**STATE OF TENNESSEE
DEPARTMENT OF TRANSPORTATION**

INSTRUCTIONAL BULLETIN NO. 16-02

Regarding Revised Standard Drawings

Effective June 24, 2016 letting (April 13, 2016 Turn-in), the following Standard Drawings have been revised. Also, Section V of the Roadway Design Guidelines has been revised to incorporate these changes.

NOT TO SCALE 5-27-95 D-CB-25RA

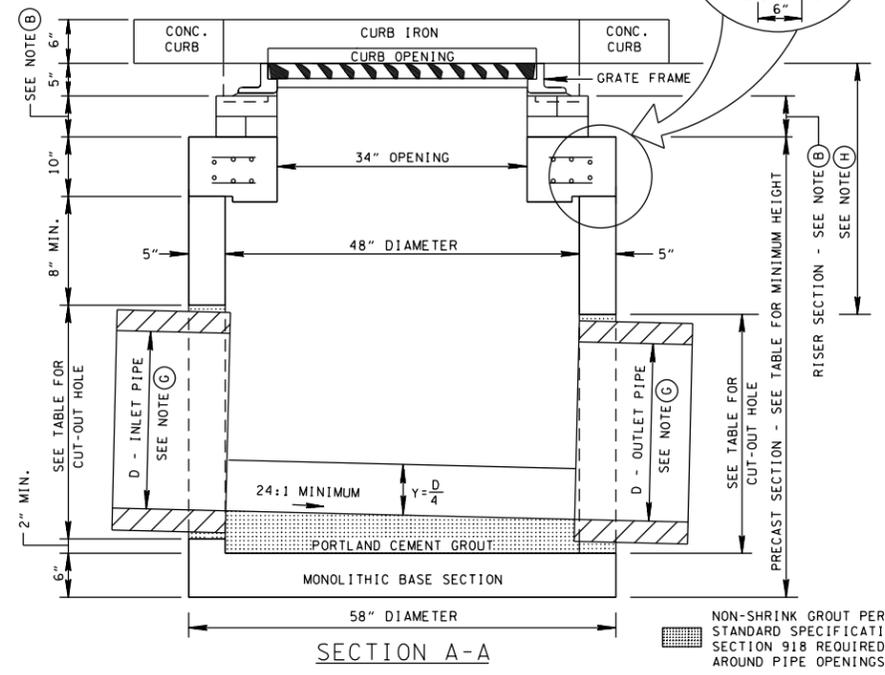
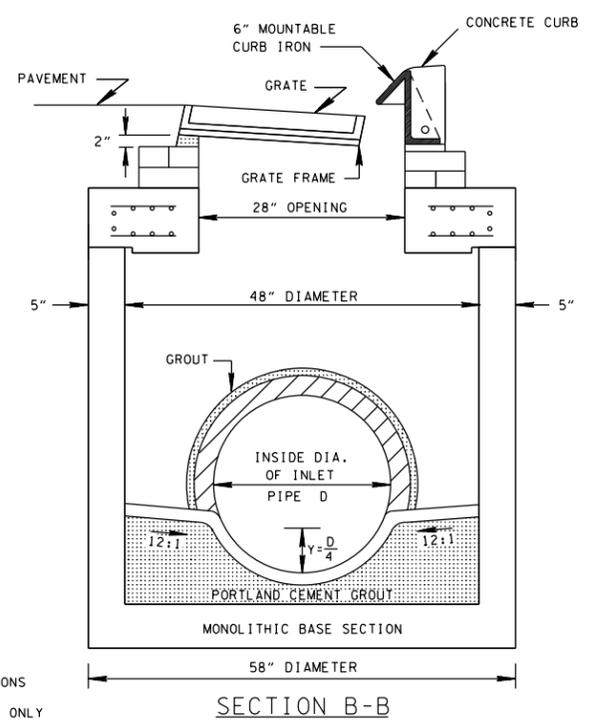
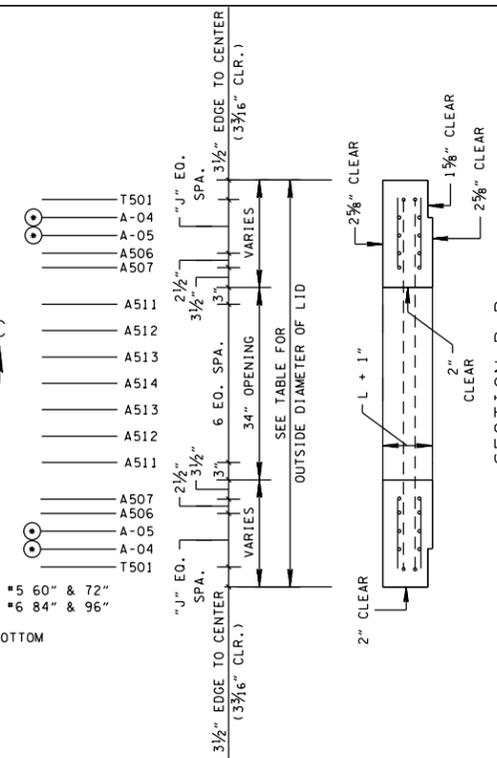
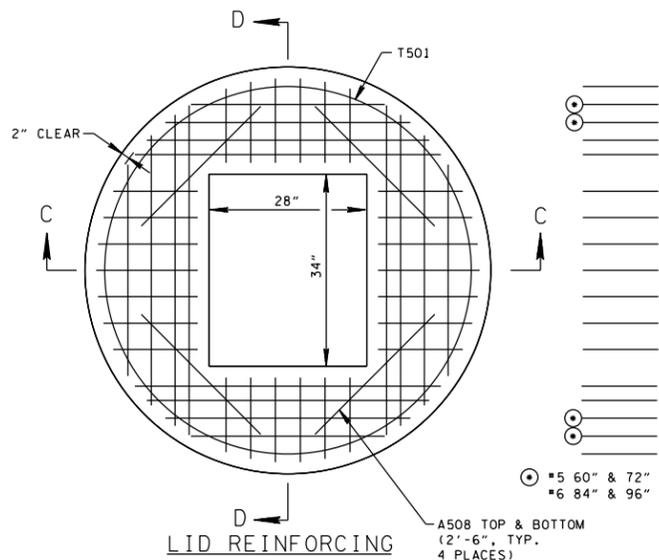
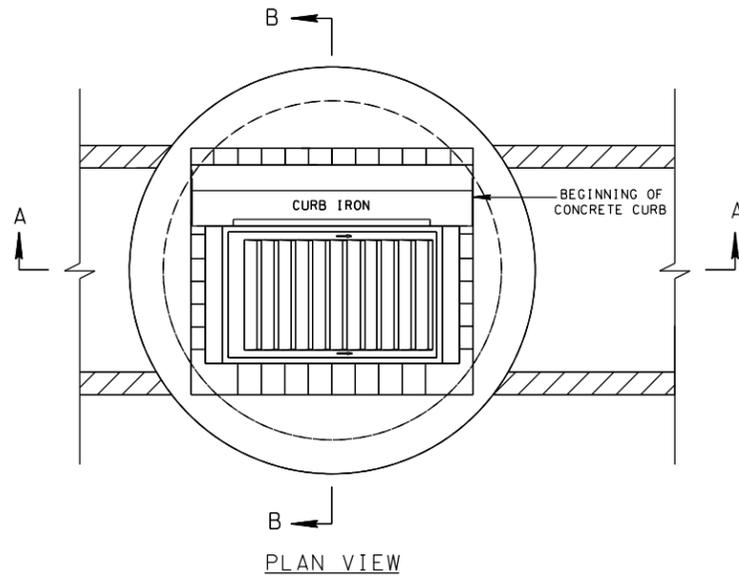
- REV. 9-24-12: MODIFIED TOP SLAB AND MINIMUM DEPTH.
- REV. 3-11-14: ELIMINATED STIRRUPS.
- REV. 1-27-16: CORRECTED GENERAL NOTE (I).

STANDARD
MASONRY & PRECAST
NO. 3 MANHOLE

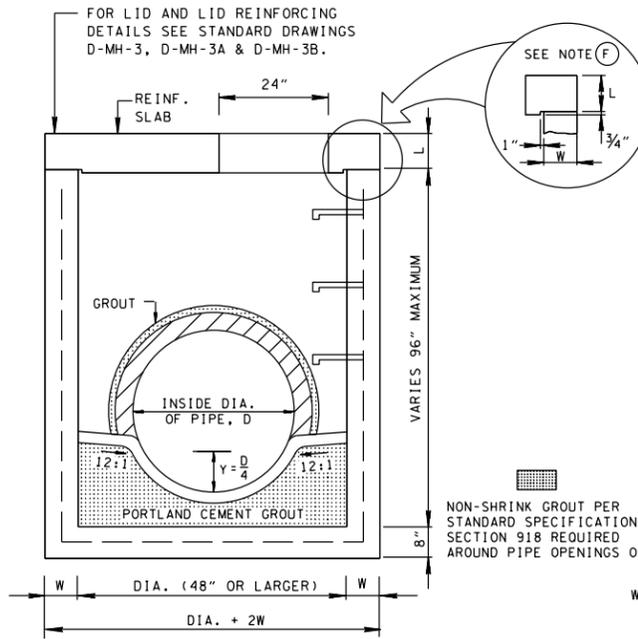
- REV. 8-01-12: REVISED CUT-OUT HOLES TABLE, SHALLOW BRICK MANHOLE TOP SLAB DETAIL AND ADDITIONAL MISC. DRAFTING EDITS. ADDED 48" MANHOLE.
- REV. 2-2-16: CORRECTED SHALLOW BRICK MANHOLE TOP SLAB DETAIL NOTE.

STRAIGHT TYPE CONCRETE ENDWALL

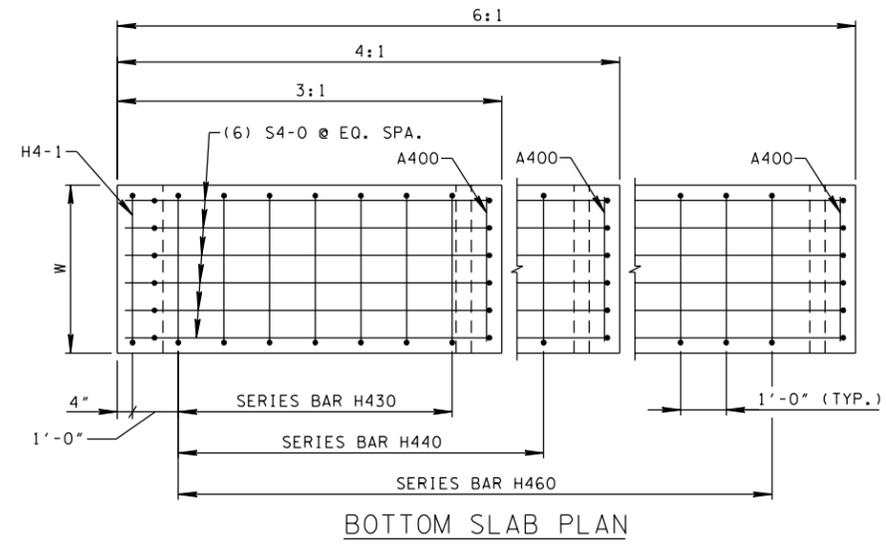
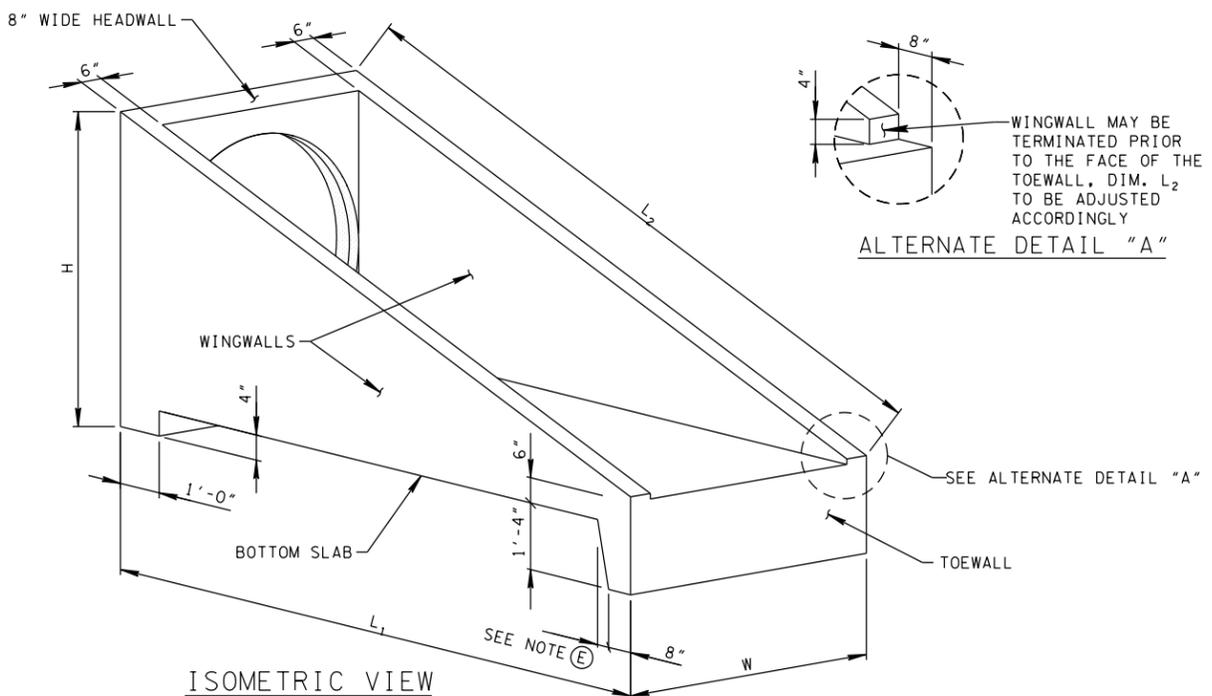
- REV. 6-14-13: REVISED NOTEG. ADDED NOTE (H) AND (I).
- REV. 1-6-15: REVISED HOLE OPENING SIZE. ADDED STEPPED HOLE DETAIL.
- REV. 1-21-16: REVISED GENERAL NOTE (B).

- (B) ALL STRAIGHT CONCRETE ENDWALLS ON THE INLET END OF PIPE, AND AT 90° SKEW SHALL BE BEVELED AT 3" AT AN 45° ANGLE. BEVEL WILL NOT BE REQUIRED WHEN ENDWALL IS CONSTRUCTED ON THE "BELLED" END OF CONCRETE PIPE.

NOT TO SCALE 3-01-12 D-PE-30A

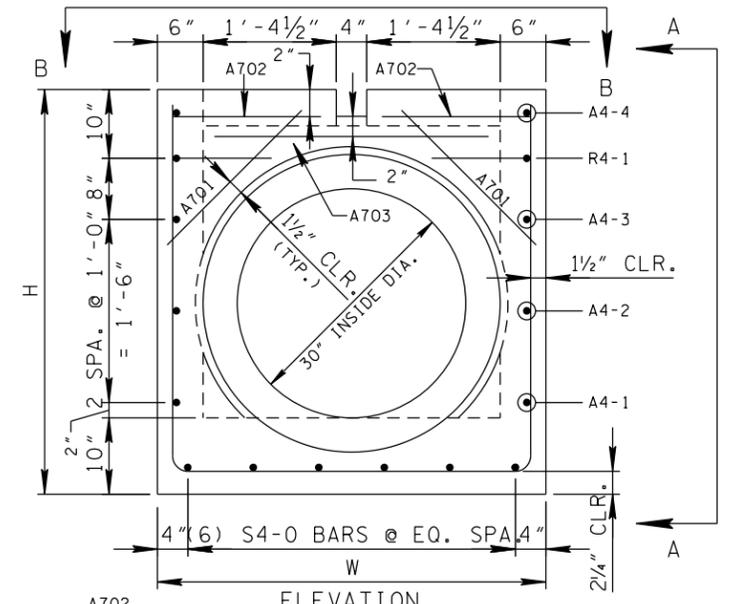
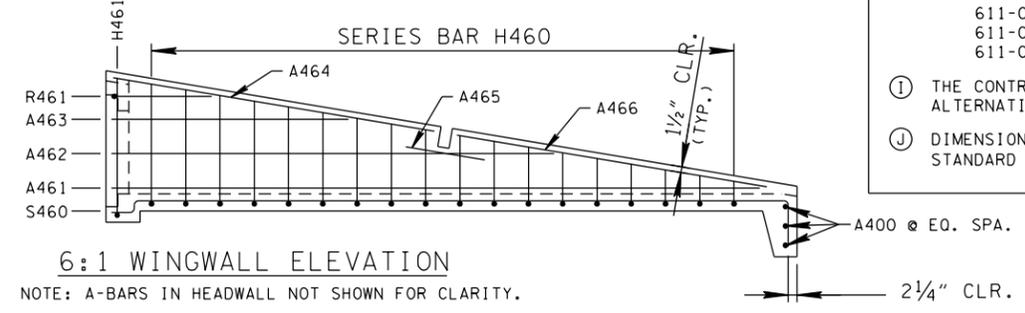
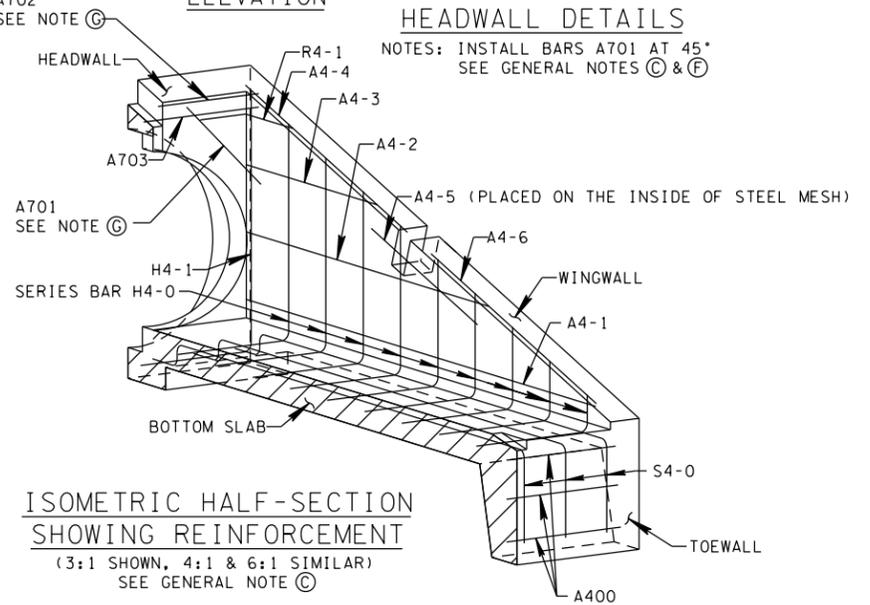
- REV. 6-14-13: REVISED NOTEG. ADDED NOTE (H) AND (I).
- REV. 1-6-15: REVISED HOLE OPENING SIZE. ADDED STEPPED HOLE DETAIL.
- REV. 1-21-16: REVISED GENERAL NOTE (E).

- (D) SPLICING OF REINFORCEMENT IS ACCEPTABLE PROVIDED THAT A MINIMUM 21\"/>
- (E) TOEWALL BACK SLOPE MAY BE CONSTRUCTED VARIABLE FROM VERTICAL UP TO 15°.

1-28-92 D-SLD-1

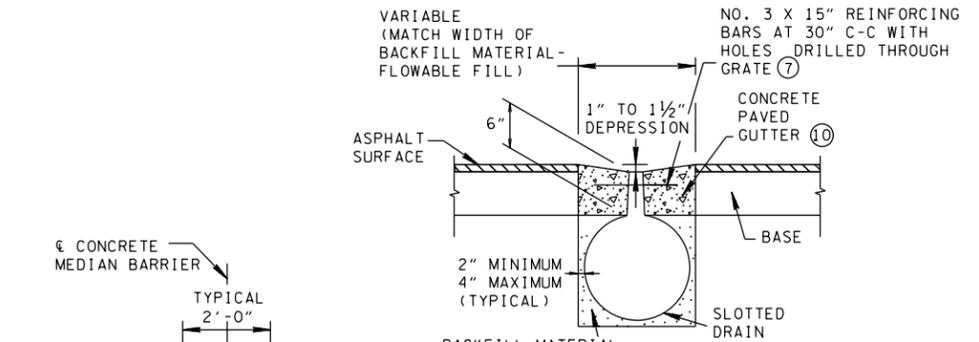
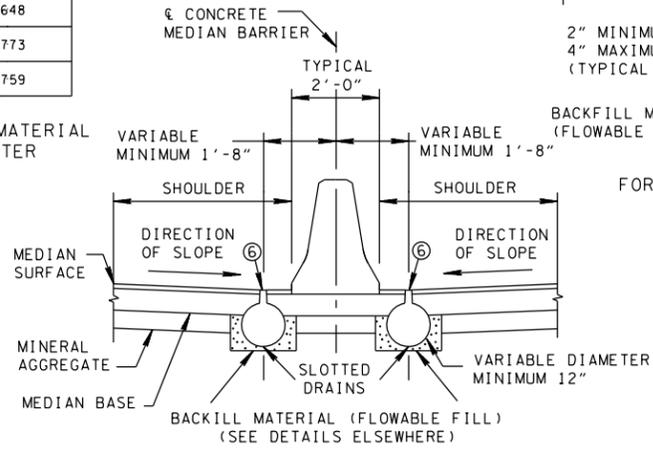
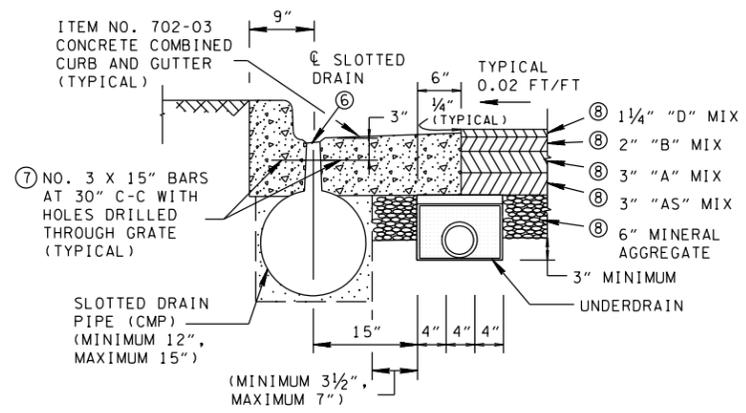
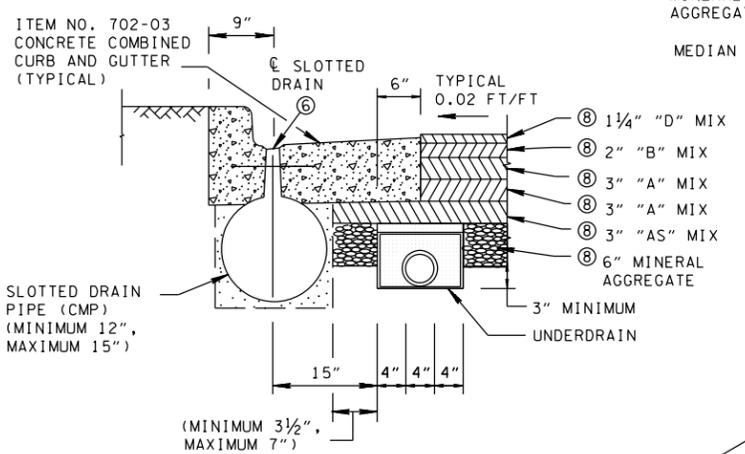
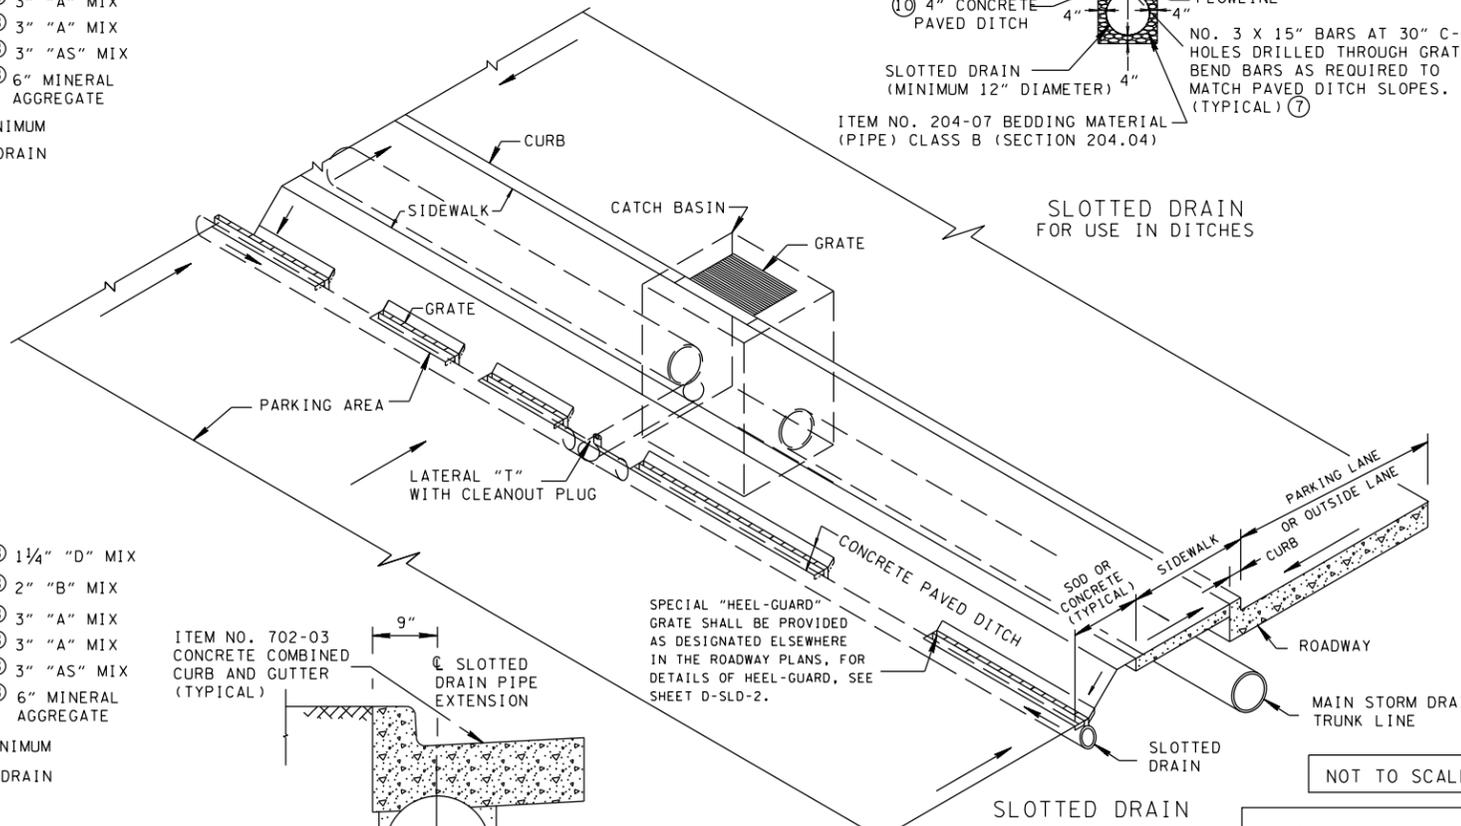
- REV. 10-26-95: CHANGED DESCRIPTION OF PAY ITEM NO. 204-08.01. CHANGED FOOTNOTE NOS. (4) AND (7).
- REV. 10-26-96: IN MISCELLANEOUS ITEM LISTING CHANGED ITEM NO. 702-03.05 TO 702-03.
- REV. 12-18-97: CHANGED REFERENCE THROUGHOUT DRAWING OF FLOWABLE MORTAR TO BACKFILL MATERIAL (FLOWABLE FILL).
- REV. 5-27-01: CHANGED DESCRIPTION FOR ITEM NO. 204-07.
- REV. 2-2-16: CORRECTED PAY ITEM NUMBERS.

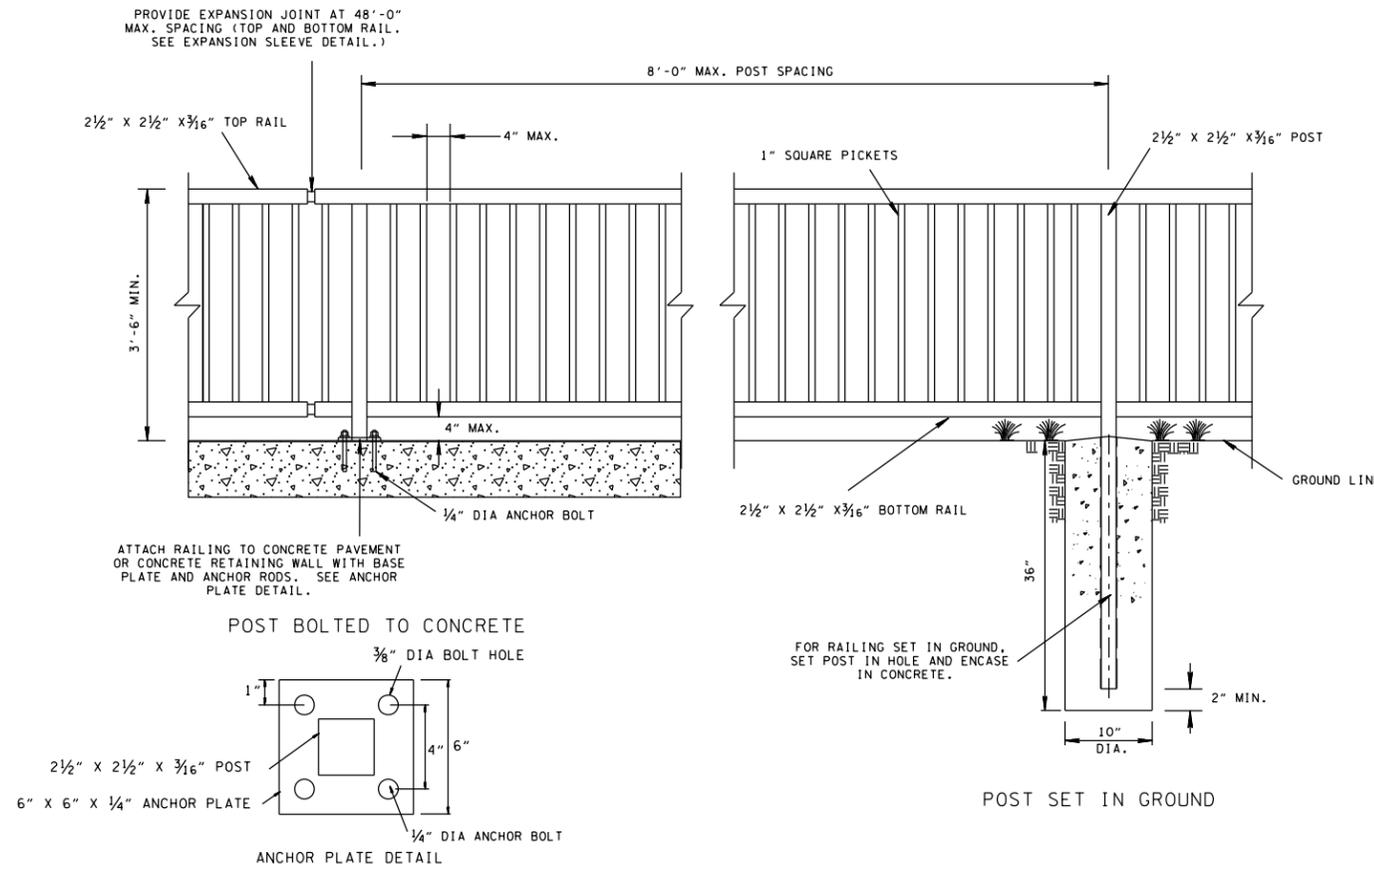
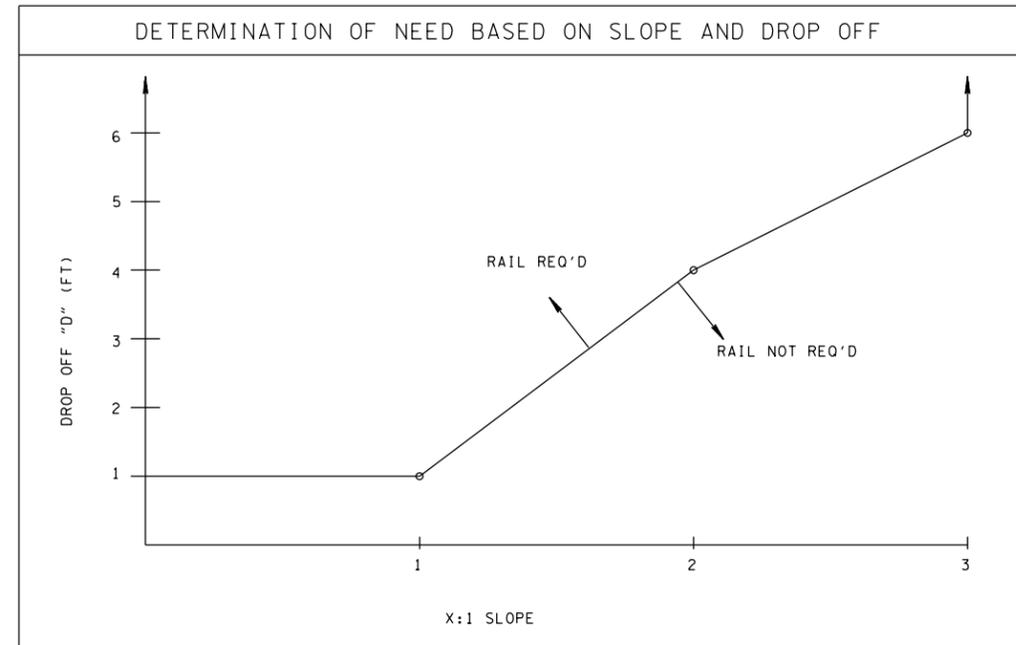
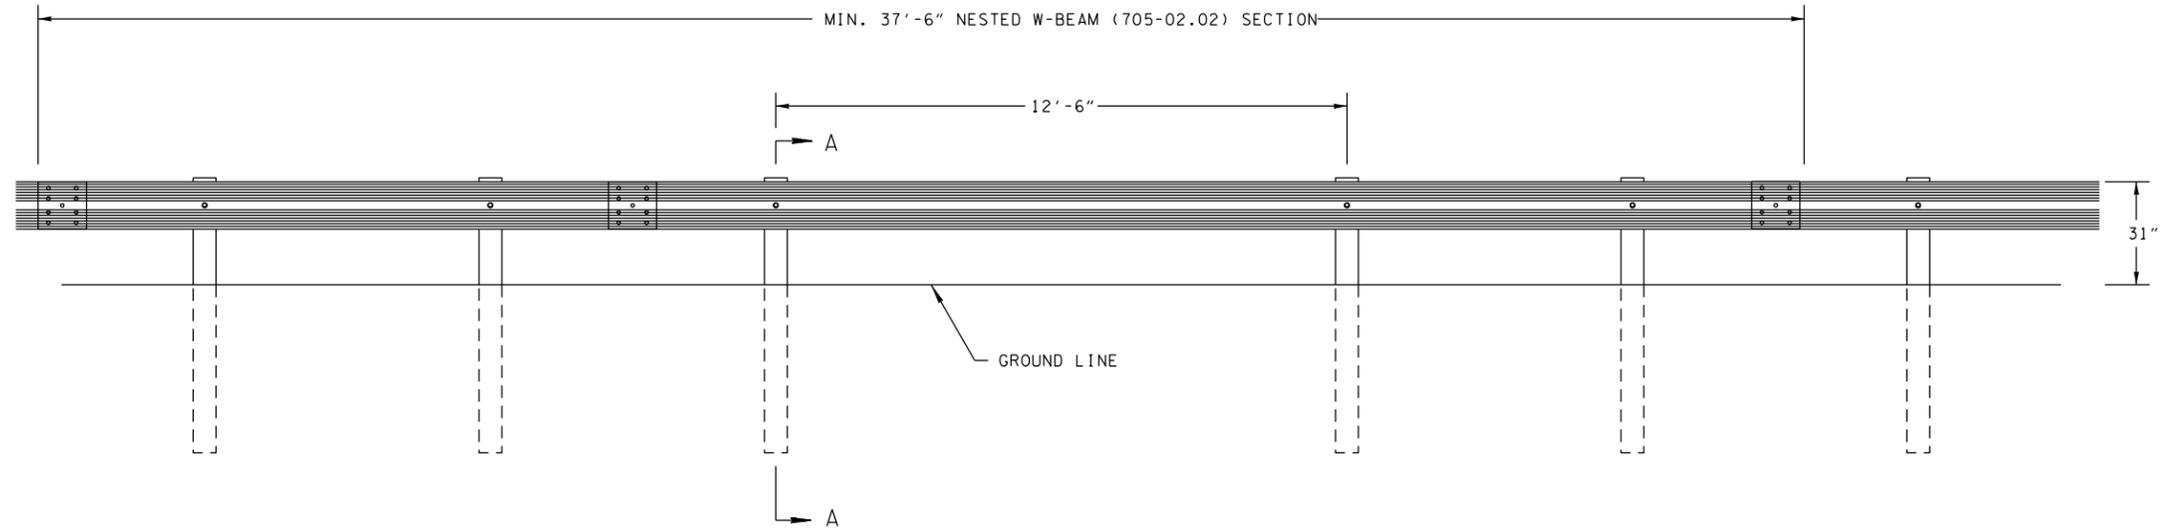
- REV. 4-11-14: ADDED NOTE ⑦.
- REV. 2-5-16: ADDED WALL SECTION DETAIL.
